NOTE:
BUILDING REVISIONS TO S.D.P. 84-287
ALL PAVING, CURB & GUTTER & UTILITIES ARE EXISTING.

DESIGNED JME	REVISED SITE DEVELOPMENT PLAN BUILDING 3, PARCEL B-1	SCALE 1" = 30'
DRAWN VHL	ROCKBURN COMMONS	DRAWING 1 of 1
CHECKED JME	SECTION 1 1ST ELECTION DISTRICT HOWARD COUNTY, MARYLAND	JOB NO. 86-071
DATE 8-18-86	FOR THE RYLAND GROUP, INC. 7130 Minnifield Way, Suite 215 Columbia, Md. 21045	FILE NO. 86-071 X

SDP-87-37

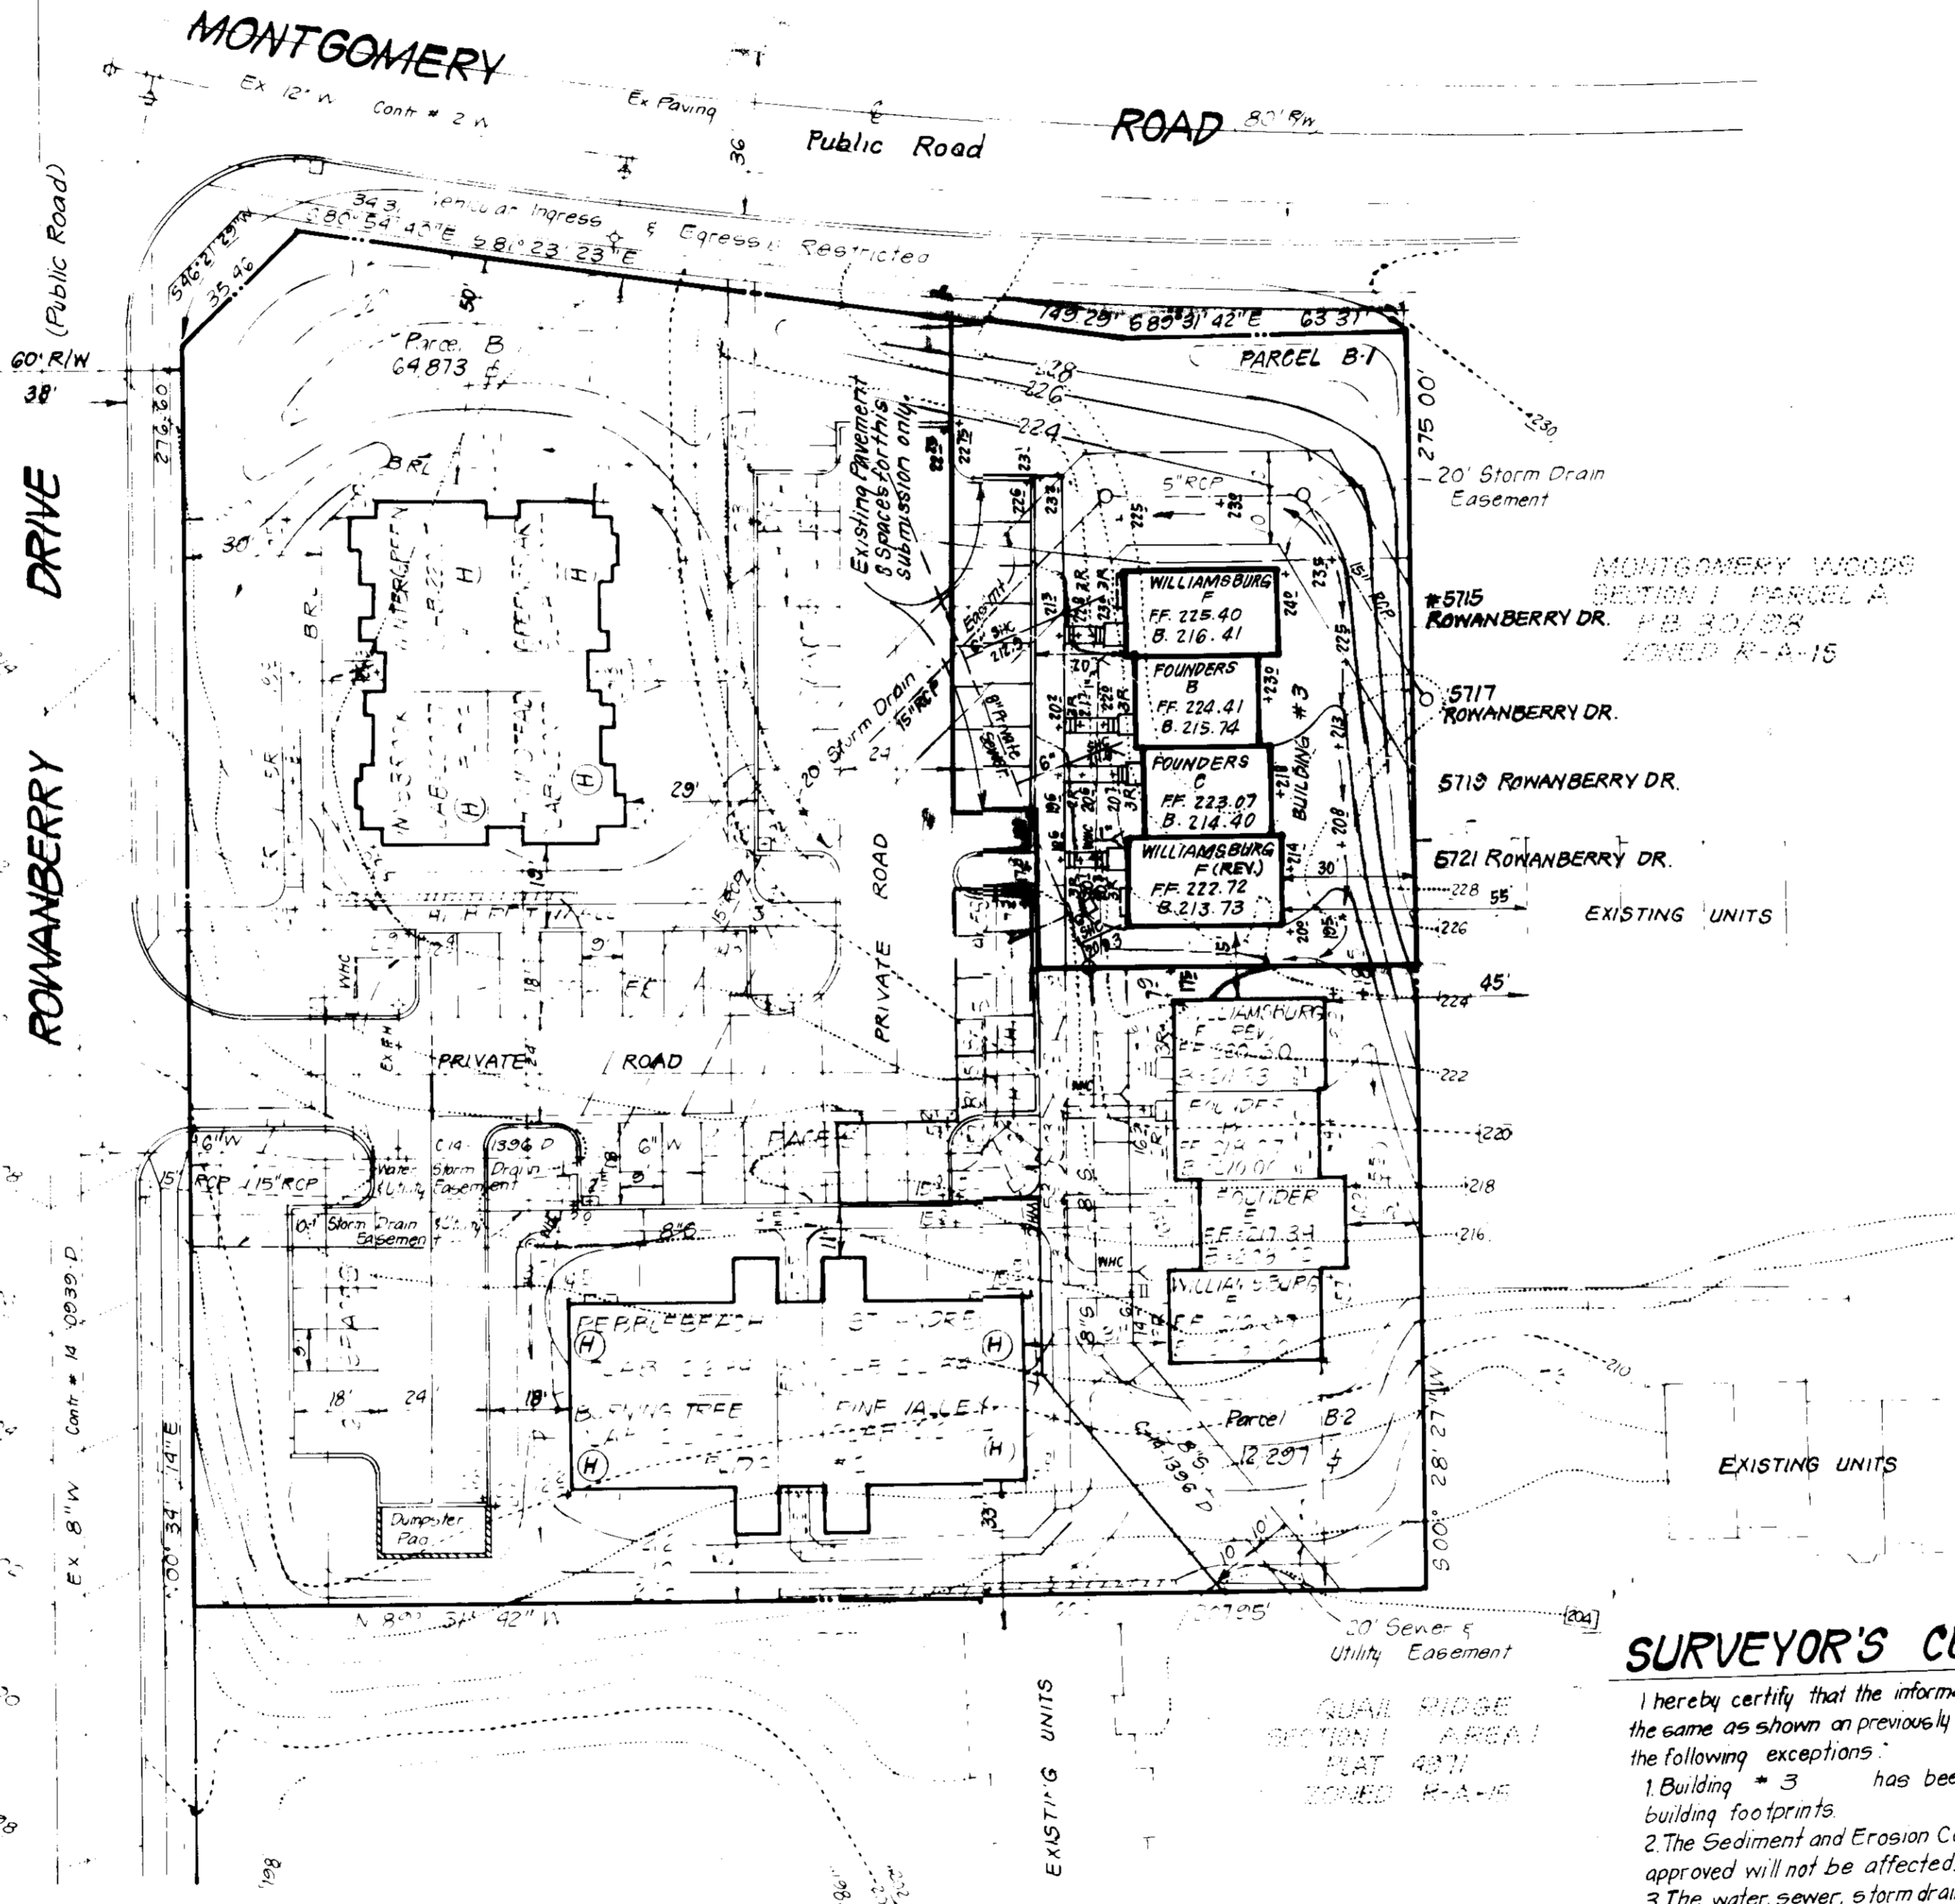
I hereby certify that the information contained hereon is the same as shown on previously approved S.D.P. 84-287 with the following exceptions:

- Building # 3 has been revised to show current building footprints.
- The Sediment and Erosion Control Measures as previously approved will not be affected.
- The water, sewer, storm drainage and paving are the same as previously approved.
- The grading is substantially the same as previously approved.
- The Lot has the same geometric configuration as shown on the subdivision plat.
